**Re: Petition 1347A - GRE GACRUX LLC Petition for a Declaratory Ruling, Pursuant to Connecticut General Statutes §4-176 and §16-50k, for the Proposed Construction, Maintenance and Operation of a 16.78 MW AC Solar Photovoltaic Electric Generating Facility Located at 117 Oil Mill Road and Associated Electrical Interconnection to Eversource Energy's Existing Substation at 325 Waterford Parkway North in Waterford, Connecticut. Reopening of this Petition Based on Changed Conditions Pursuant to Connecticut General Statutes §4-181a(b).**

**Petition No. 1347A**

**GRE GACRUX LLC'S RESPONSES TO THE CONNECTICUT  
SITING COUNCIL'S FIRST SET OF INTERROGATORIES**

**Stump Grubbing Map**

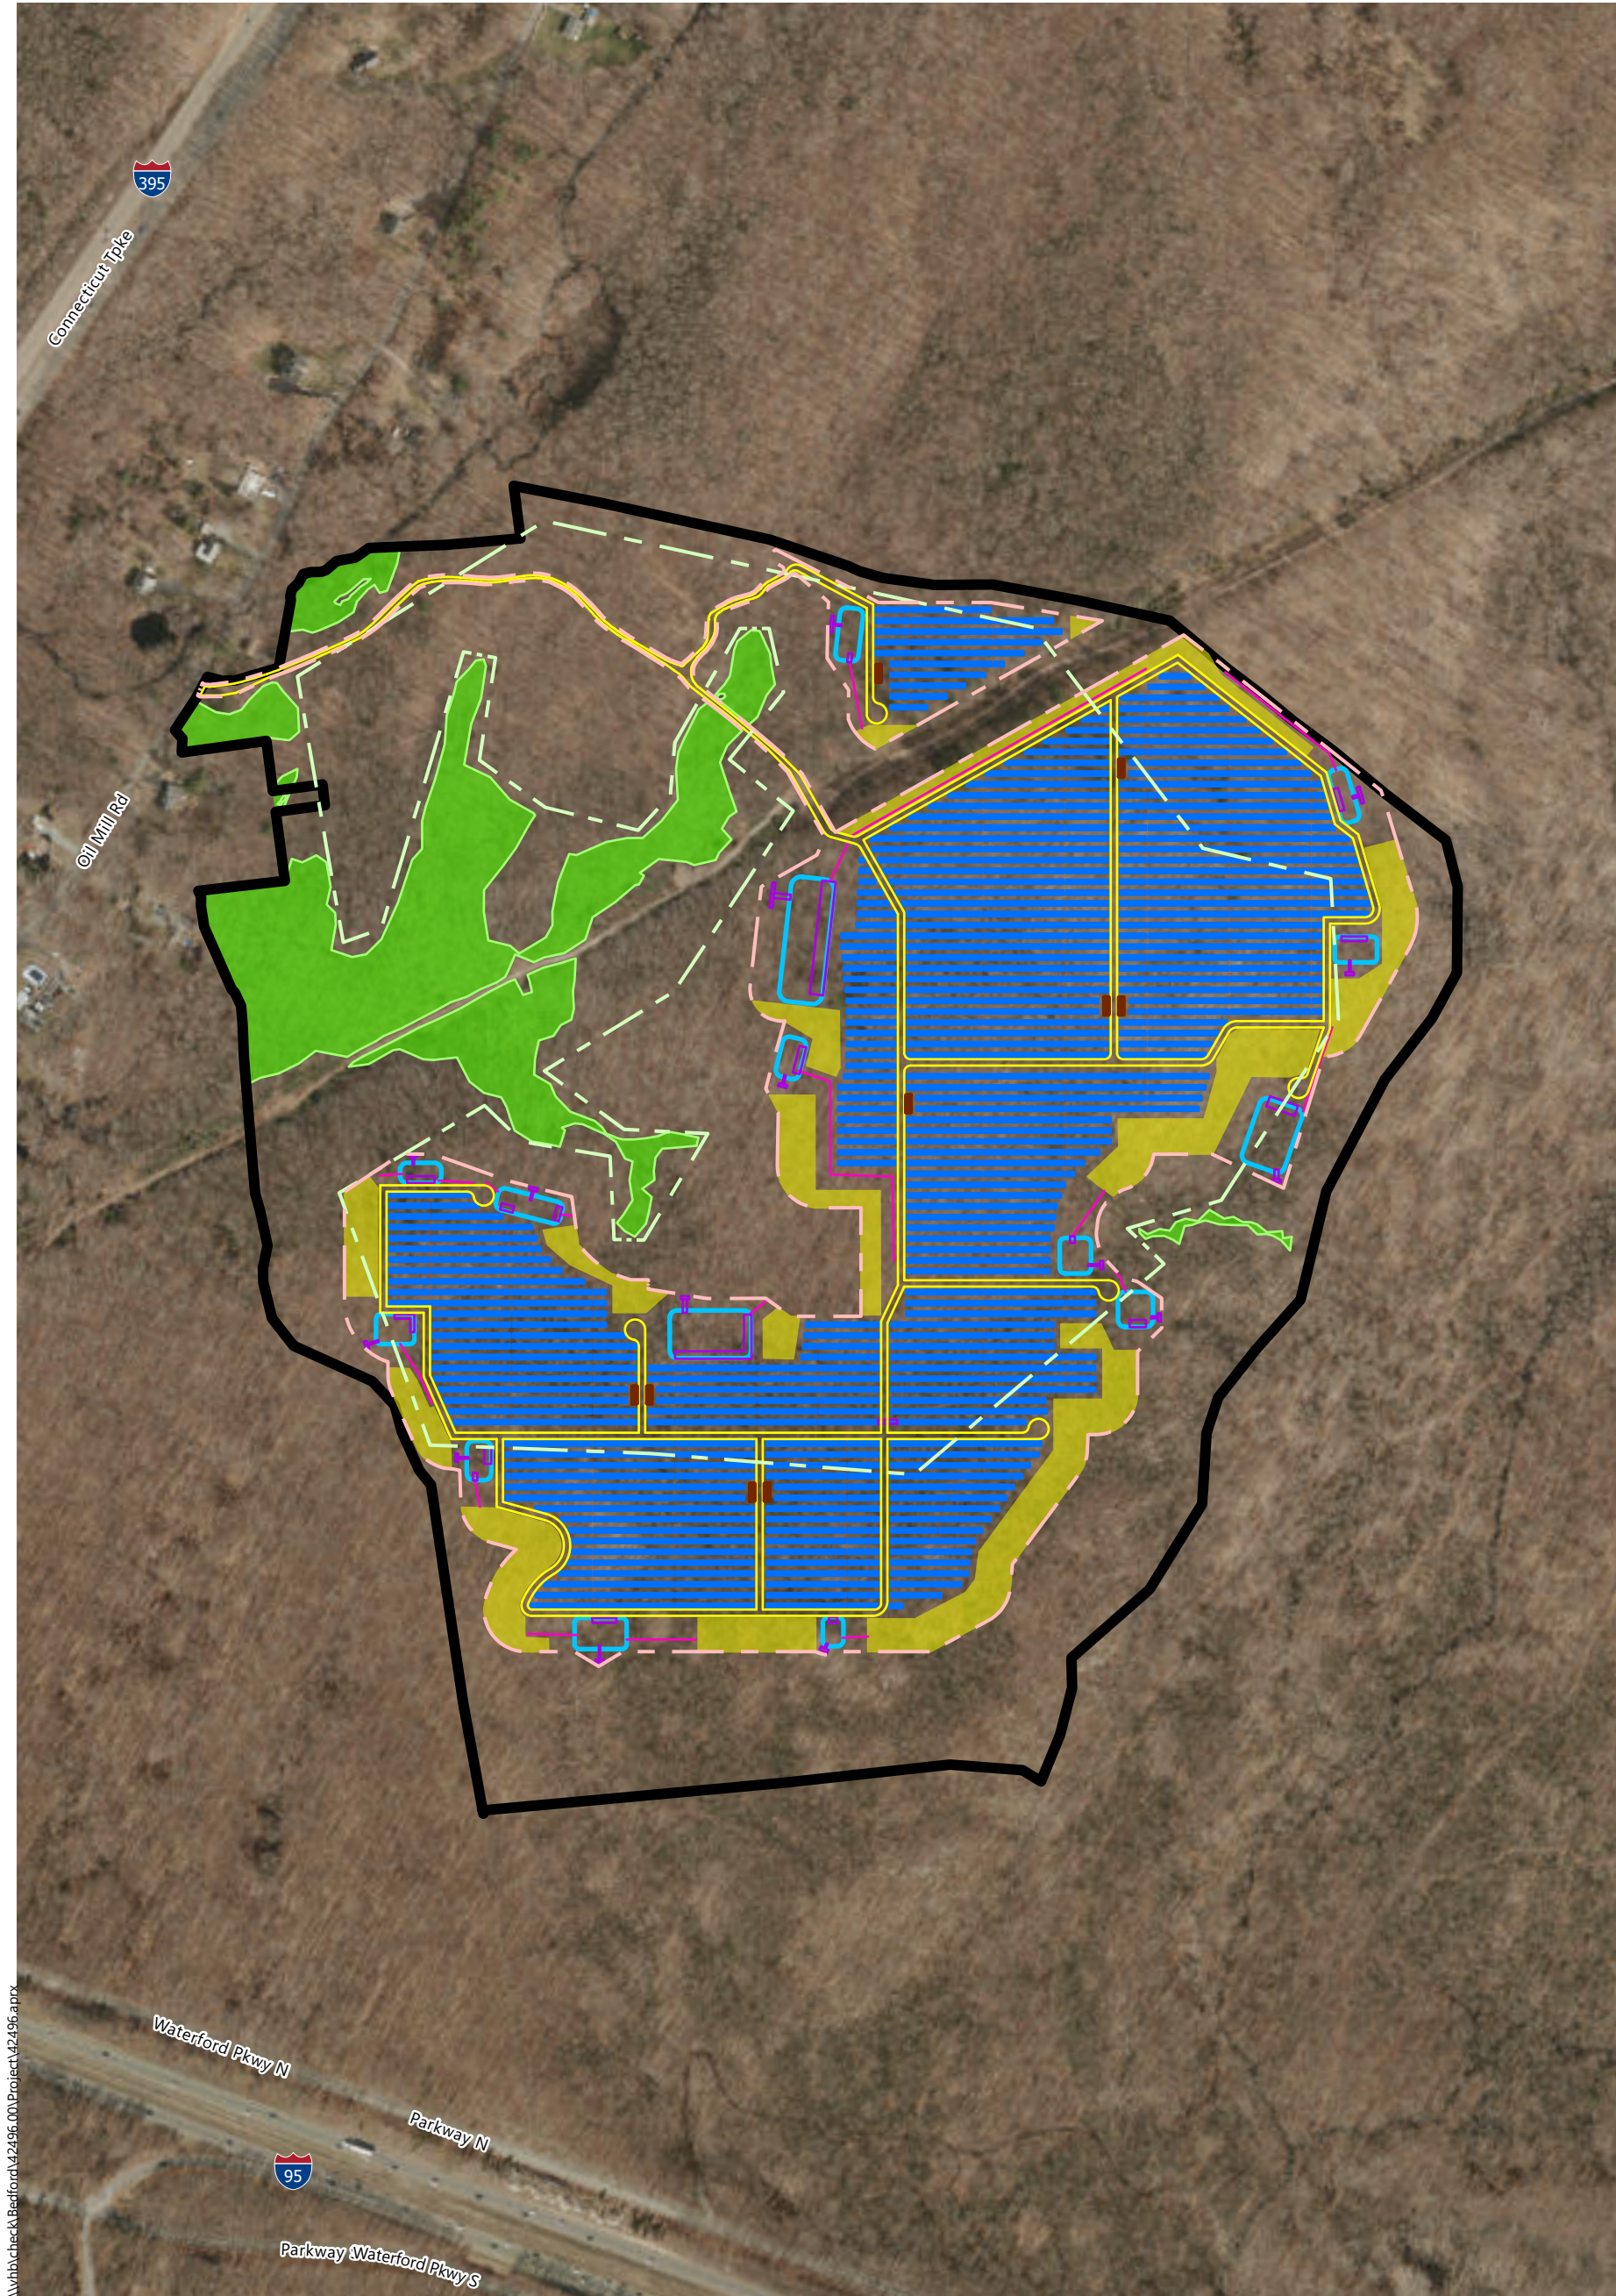
8. Referring to Petition p. 13, a Project area of 75 acres is given. Specify the approximate acreage of grubbing and non-grubbing.

Relating to the approximate 75 acres of tree clearing necessary to construct the project, it is proposed that approximately 65 acres shall be grubbed. The remaining 10 acres are proposed to have the stumps left in place. A plan entitled Stump Grubbing Map has been prepared portraying the proposed distinction between grub and no-grub areas of the Project for clarity. It is included as Exhibit A.

**Figure 1**  
**Solar Panel Installation with Slopes  $\leq 5\%$**

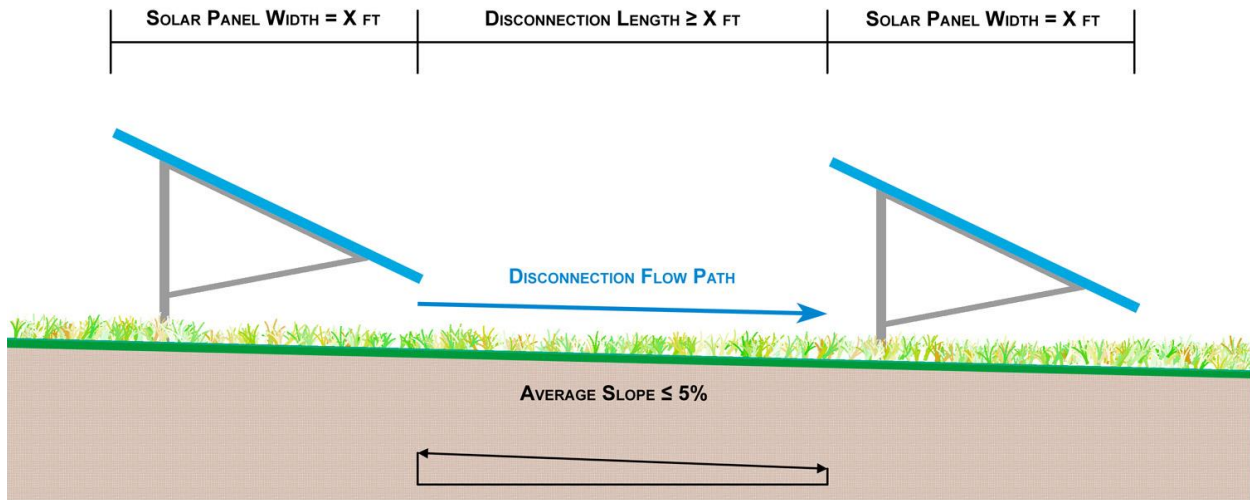
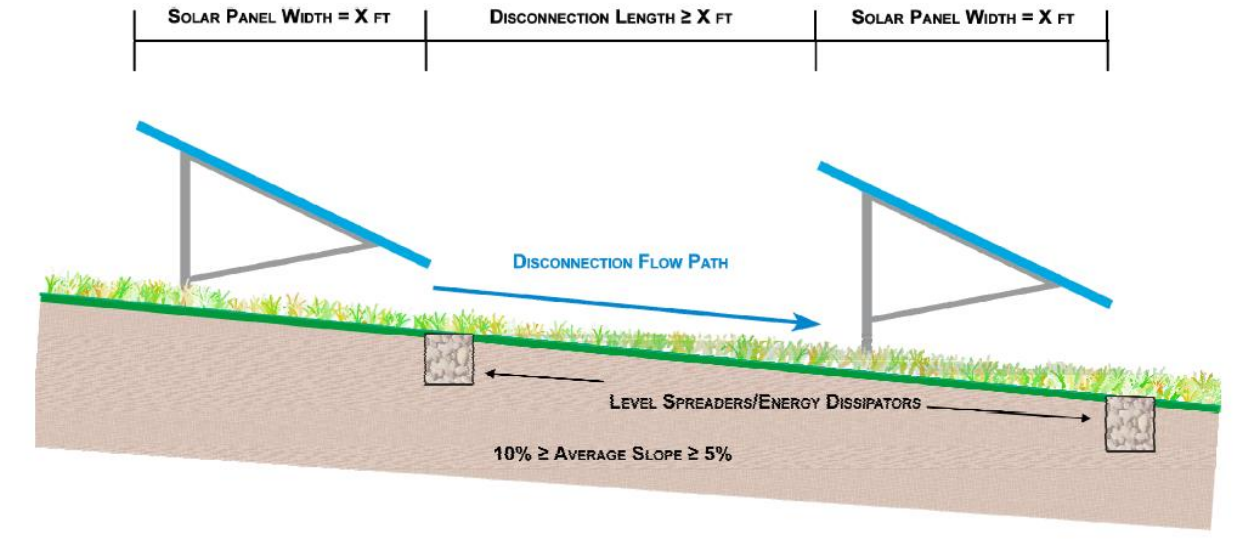
28. Were post-construction slopes factored into the stormwater design using the slope criteria in Solar Appendix I? In what areas will different stormwater controls be necessary to comply with Solar Appendix I? Submit a diagram showing post-construction slopes using thresholds described in Solar Appendix I.

Post-construction slopes were considered in the overall site plan and stormwater design. Rather than only using hydroseed with tackifier on slopes greater than 8%, it is proposed to use hydroseed with tackifier at multiple intervals throughout construction to assist in the stabilization of the entire project area. It has also been incorporated into the construction sequence that the entire project area will be cleaned from the recent timber harvest and erosion controls will be installed and allowed to vegetate through a growing season before the development aspects of the project are implemented. The project as a whole has been pulled back from some of the steeper areas along the property lines to help minimize the amount of work on steep slopes, and it is proposed to regrade existing slopes exceeding 15% within the project limits to be under that threshold to the extents practicable. Lastly, it is proposed that stormwater runoff from all development areas will be captured by a system of excavated sediment traps, basins, and engineered swales. A diagram of post-construction slopes using the thresholds described in Solar Appendix I is enclosed herewith as requested as Exhibit E.
